**RE: Response to Comments and Transmittal of Pre-Design Investigation Work Plan Revision 1
Green Bay Former Manufactured Gas Plant
Green Bay, Wisconsin
Wisconsin Public Service Corporation
CERCLA Docket No. V-W-06-C-847, CERCLIS ID – WIN000509948**

PRE-DESIGN INVESTIGATION WORK PLAN REVISION 1 FORMER GREEN BAY MANUFACTURED GAS PLANT SITE

Project name **Former Green Bay MGP**
Project no. **70712**
Recipient **Wisconsin Public Service Corporation**
Document Type **Pre-Design Investigation Work Plan**
Revision **1**
Date **August 12, 2020**
Prepared by **Sarah Jo Martens**
Checked by **Staci Goetz**
Approved by **Brian Hennings**

FIGURE 8

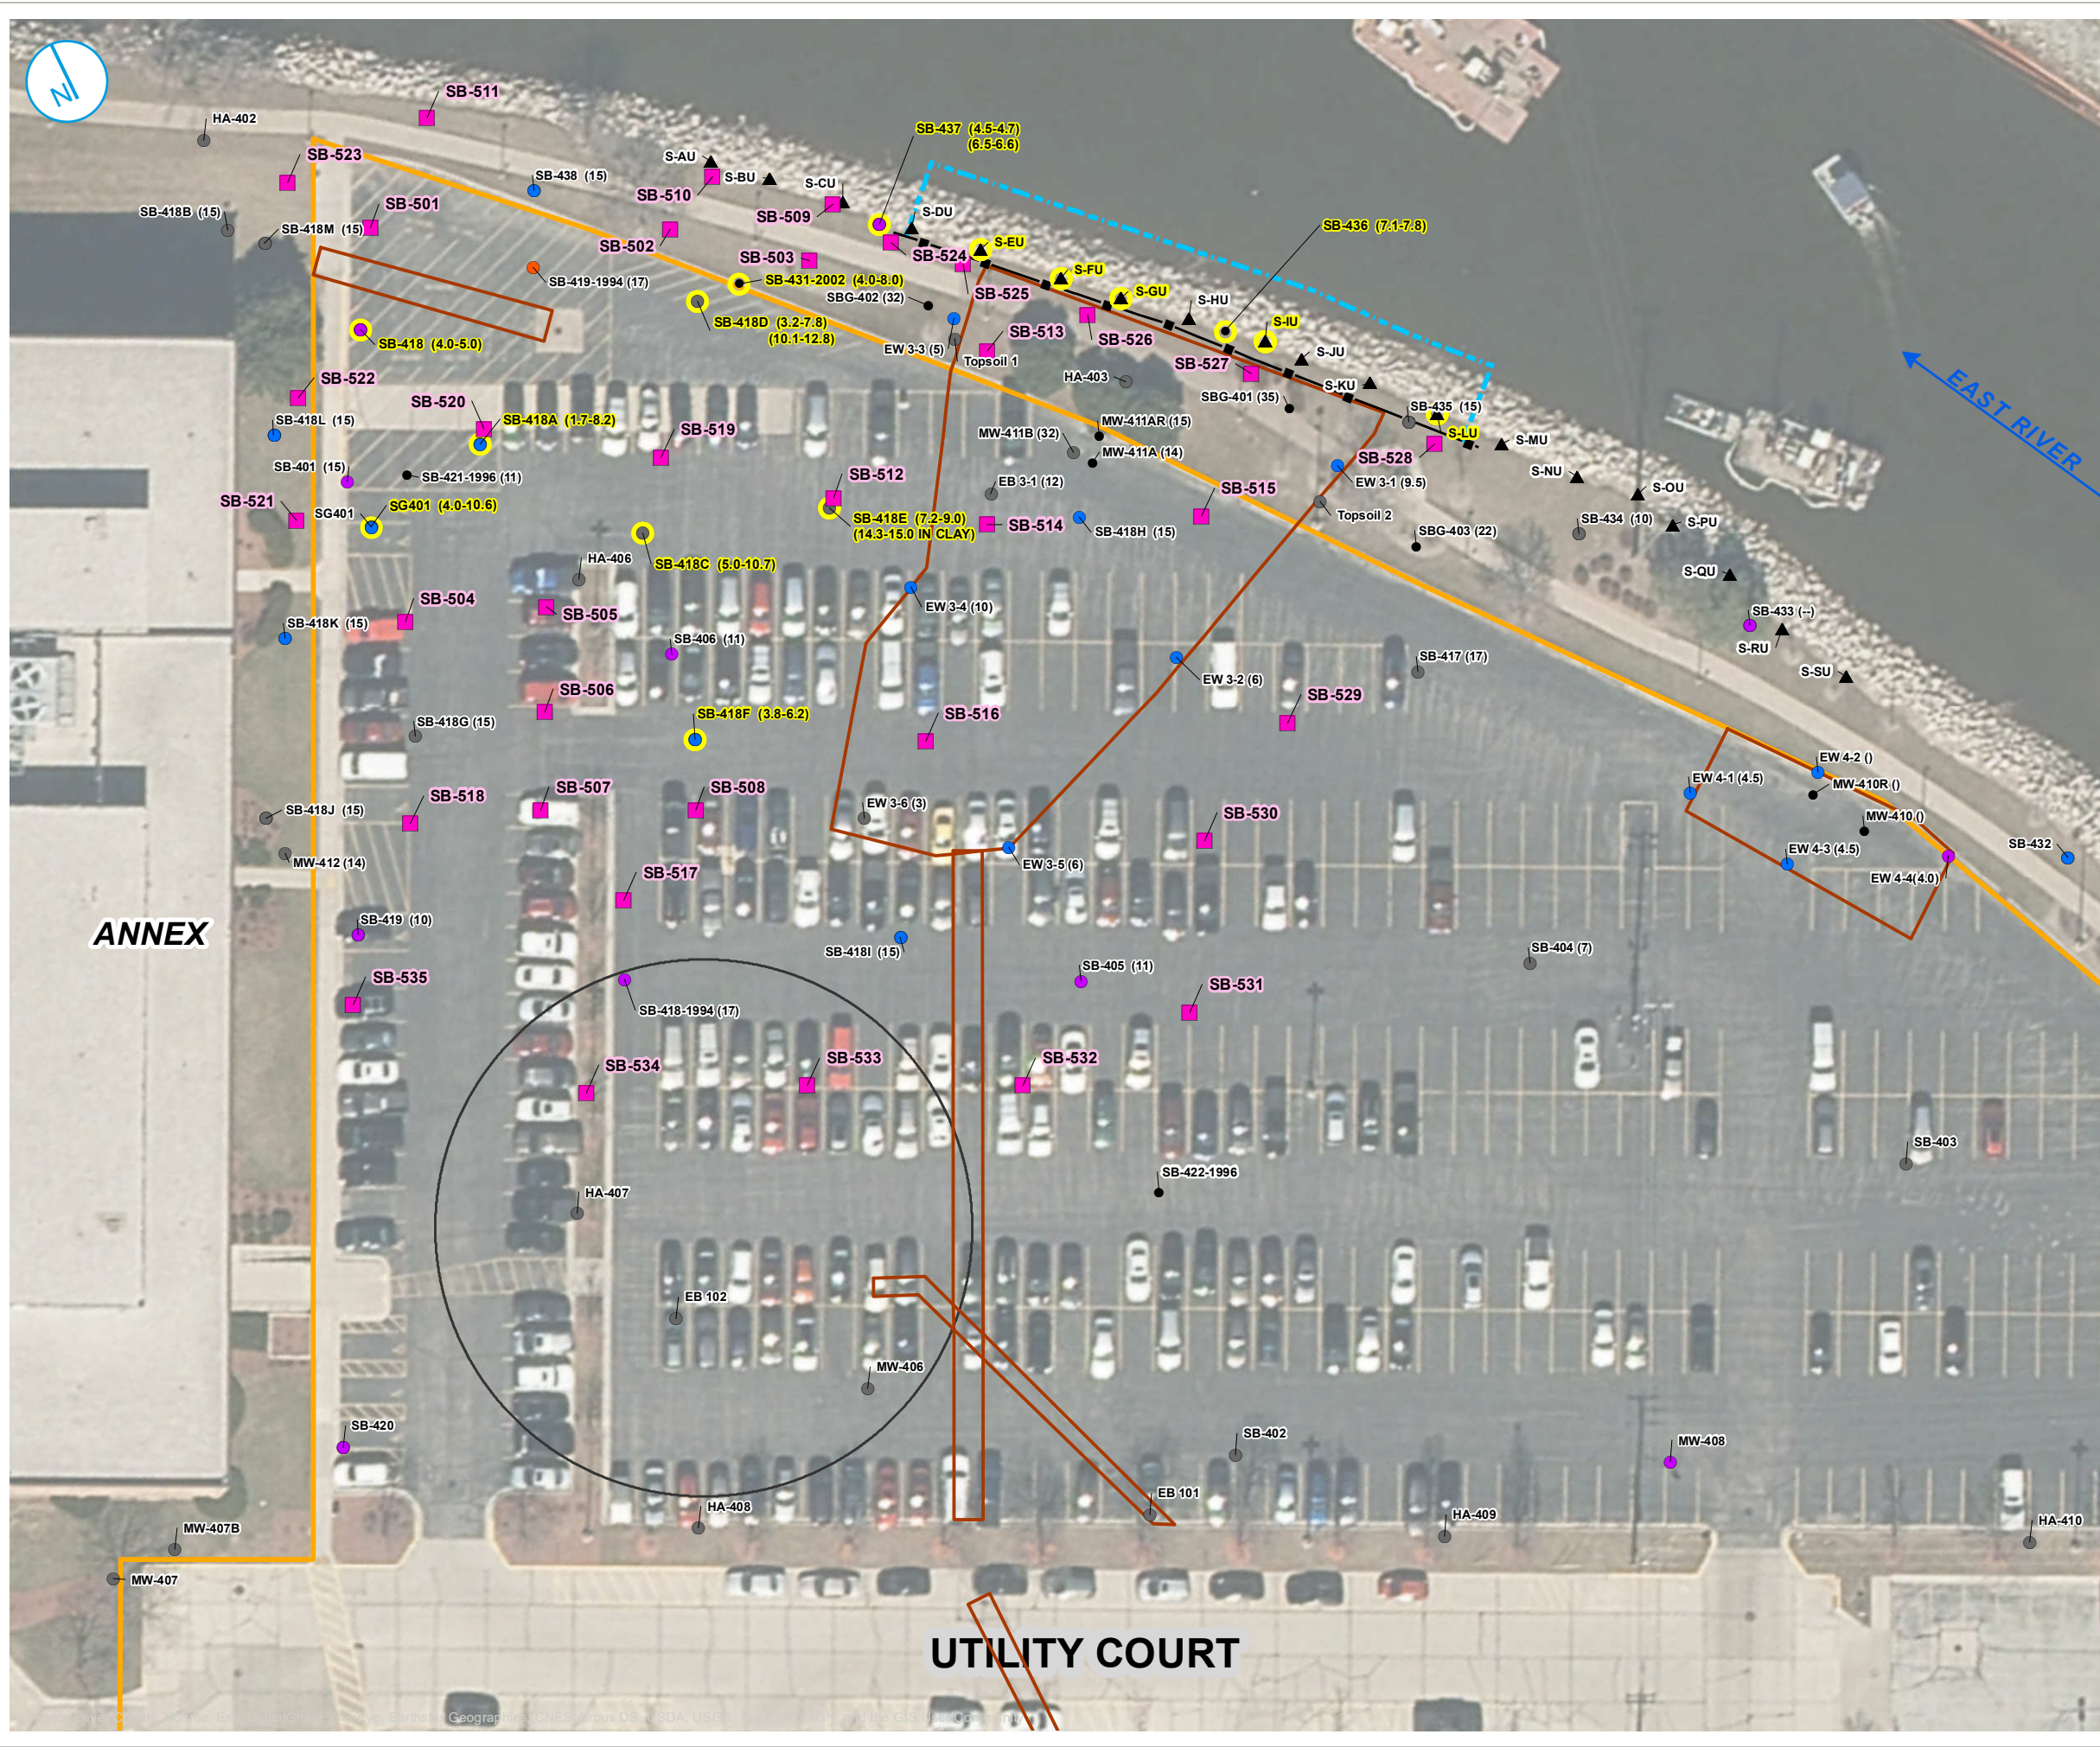
2. *Additional soil borings are recommended along the land-side of the sheet pile wall installed as part of the 2003 soil removal action. Approximate suggested locations are shown as red rectangles on the annotated Figure 8, PDI Work Plan (Attachment 2). The purpose of the sample locations would be to see if NAPL exists at any depth behind the wall, either outside the 2003 removal action footprint, or underneath the footprint, or within if NAPL migrated to a more permeable layer.*

15. *Section 3.3.1 - Please include the spacing that will be utilized for the contingency borings and update Figure 8 to include potential locations.*

WPSC Response: Additional soil borings (SB-524 through SB-528) have been included in the PDI Work Plan as shown on the revised Figure 8. The proposed locations include area within the thermally treated backfill and adjacent to the sheet pile wall as recommended.

WPSC Response: Contingency boring locations will be determined based on visual results of the initial PDI borings. Step out borings will generally be placed equidistant between the PDI boring containing a visual result and a location previously investigated.
